3.14 Secured by Design

MW-A met with Jim Cope, Police Constable and Design Out Crime Officer for the London Metropolitan Police on 23.01.18. Following this meeting Jim Cope issued his comments on the design on 25.01.18. The main points of which have been numbered and highlighted on the plan to the left with analysis and commentary by MW-A in green below.

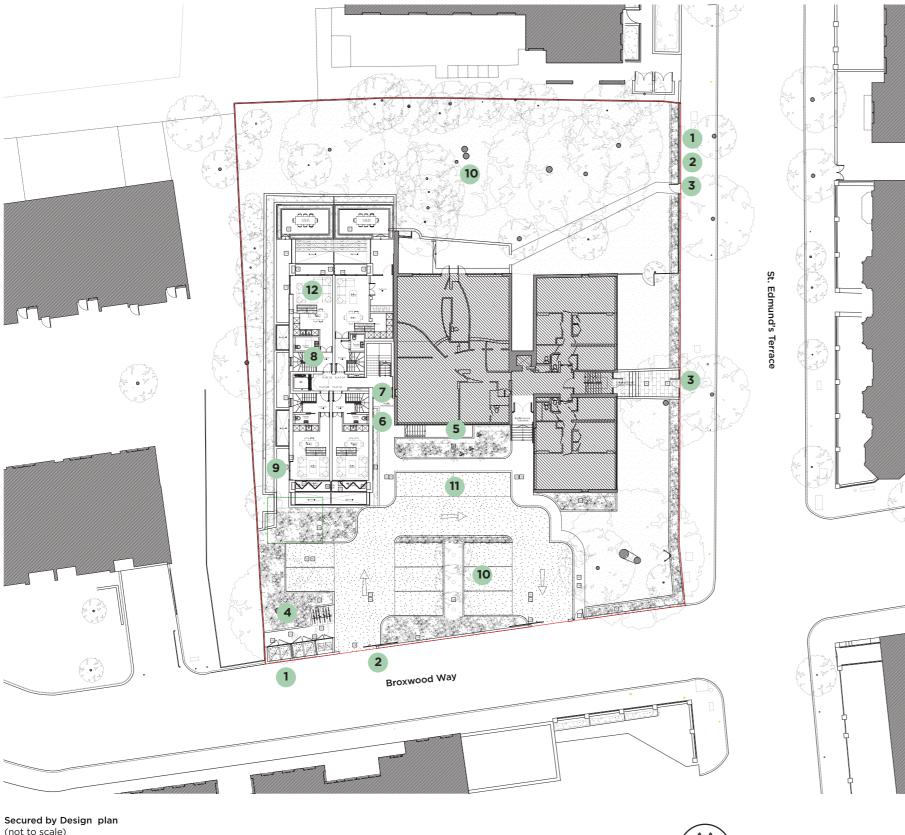
"The boundary around the perimeter of the development is going to be a low brick wall topped with metal railings. On the interior of this boundary at certain locations there will be planting and this should be a minimum of Im in depth". Noted, Im planting zone to be provided around the perimeter of the development, where applicable.

"The railings should be designed to make climbing awkward". Noted, railings are to be designed in line with guidance

"The Two (2) pedestrian gates are going to be FOB access controlled, they should on a self-locking and self-closing mechanism. The 'push to release' mechanism for exiting the development should be far away from the gate to prevent a person reaching through and being able to activate it with either

their own hand or using an implement to extend their reach". Noted, gates to be designed in line with guidance

(4) "With the visitors cycle storage area ... I am now happy with the current location. It is overlooked by an 'active' room from the nearby flat". Noted.

"The internal cycle storage area will have a PAS 24:2016 door and is accessed via a FOB control... with a self-locking/self-closing mechanism, internal thumb turn lock on in the interior to prevent users being trapped inside. The 'Josta' stands chosen for the actual security of the cycles is more than adequate and satisfies the recommendation for cycle safety".

The primary entrance to Barrie House I would like to see brought further forward to eliminate the alcove and the 'blind spot' it creates for the pedestrians approaching it from the footpath. If this occurs then the main door is recommended to be LPS 1175 SR2 on a video/audio/FOB control access system".

7 "The space created will allow for an airlock entry with a further door (PAS 24:2016) on audio access control. In this space the postal strategy can be implemented".

8 "All doors to flats to be PAS 24:2016". Noted, doors to be specified as per guidance.

"All ground floor windows/doors or ones that are easily reached from the ground by climbing will be PAS24:2016". Noted, windows to be specified as per guidance.

"The trees in the communal area should maintained and canopy levels should be above One (1) metre in height to allow for clear view".

"Lighting of the external area should meet BS5489 and be operated on a 'dusk till dawn' system to allow for a continually light during the night to a 40% uniformity. LED lighting is recommended, positioned to a height that cannot allow for tampering".

"Smart Meter reading for the flats is highly recommended to prevent unauthorised entry into the building".

Noted, doors to be specified as per guidance.

Following pre-application advice the entrance has been set back from the existing Barrie House to create a breathing space between the new and the old.

As above.

Noted, all existing trees have a canopy above ground level. All new tress shall be mature specimens with a canopy above ground level.

Noted, lighting to be specified as per guidance.

Noted, smart meters to be specified.
